DEVELOPMENT CONTROL COMMITTEE

ADDENDUM

ITEM 5: (23/02633/FULL1) - WAITROSE, 45 MASONS HILL, BROMLEY, BR2 9HD (BROMLEY TOWN WARD)

APPENDIX 1: LONDON FIRE BRIGADE FURTHER COMMENTS

Figure 2: Common corridor mechanical ventilation

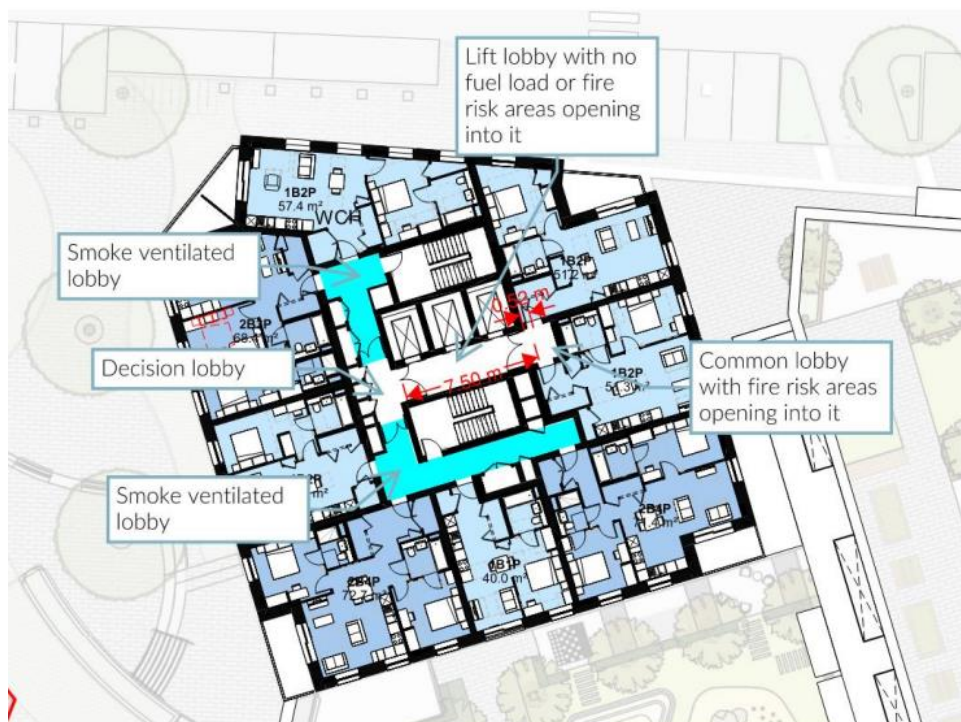
4. Mechanical smoke ventilation system extract

We note that this will be assessed in the Qualitative Design Review (QDR) process and acknowledge the spatial constraints that may present a challenge to locating the smoke extract shafts at the remote end of the corridor. We highlight that we have not been provided with floor plans of the buildings so have been unable to consider this completely. With this said, we emphasise the benefit of extracting away from the stair for safe firefighting operations and expect this to be considered/addressed at formal building control consultation stage.

5. Second staircase for all residents to access during a fire

We appreciate the initial design included the second staircase before it became mandatory. We highlight that the purpose of the second stair is to provide a suitable alternative and a safe escape for all building users should they need to, or choose to, leave during a fire including where one route may not be available. As per figure 2, flats on the south of the plan will have to travel through the lobby of one stairway to reach the other stairway, which in our opinion is not appropriate, and does not provide a true alternate route to either stairway. Design teams and developers should also be planning for the new requirements under the Building Safety Act for in scope buildings once occupied, including the need to provide a safety case review. The design as currently proposed may have implications on those responsible for demonstrating the ongoing safety in the building.

6. lift lobby

We note the commentary and justification provided, however, our opinion and comment remains unchanged. In particular we highlight that flat which opens onto an unventilated common lobby which then opens on to the evacuation lift lobby. It is unclear what consideration has been given to how a fire in this flat would impact on the lift lobby area.

- 2.2** The LFBs outstanding concerns in relation to the positioning of some of the proposed flats and their relationship to the proposed stair lobby's are noted. These matters would need to be addressed and would be subject to subsequent regulatory assessment under the Building Safety Act (2022), including the need to provide a safety case review.
